REMARKS/ARGUMENTS:

This Petition is being filed in response to an Office Action with a mailing date of May 21, 2003.

FIG. 1

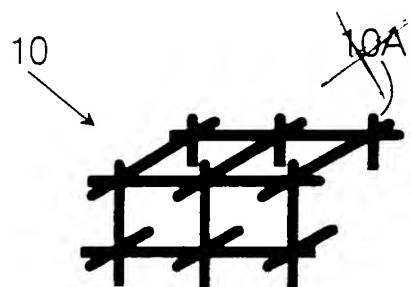
Examiner objected to FIG. 1, for including reference designation "10A" that was not mentioned in the Description. This designation was in error and has been removed from the amended formal drawing sheet. Reference designation "18A" has been added to FIG. 7. This designation refers to a wall of the container. The wall 18A and the gap between the wall 18A and the refractory mold 16 are discussed in paragraph [0030] as originally filed; thus, this amendment introduces no new subject matter. The leader line to reference designation "24" was shortened for purposes of clarity.

FIG. 8

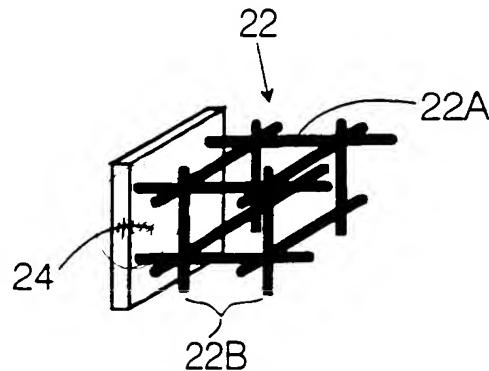
Paragraph [0025], first line, was amended to include a reference to FIG. 8, as requested by Examiner.

Claim 1 was amended to include the subject matter of claims 9 and 13. Specifically, step f) was amended to recite a second container that has "at least one opening for pouring in a molten substance and at least one container wall, wherein said second container is greater in size than said refractory mold so as to leave a gap between said refractory mold and said at least one container wall..." Also, step h) now recites the step of pouring a jacket material over said refractory mold so as to fill said gap with said jacket material to form a plate..." Step i) recites a the step of "cooling said reticular structure by maintaining a temperature of said second container, and particularly of said at least one wall, that is lower than a temperature of said molten substance so as to draw heat from said reticular structure into said second container, and particularly through said plate; ..." This step is discussed in paragraph [0030] of the Description as filed and, thus, introduces no new subject matter. The plate (24) is discussed in paragraph [0029] of the Description and shown in FIG. 8 of the application as originally filed.
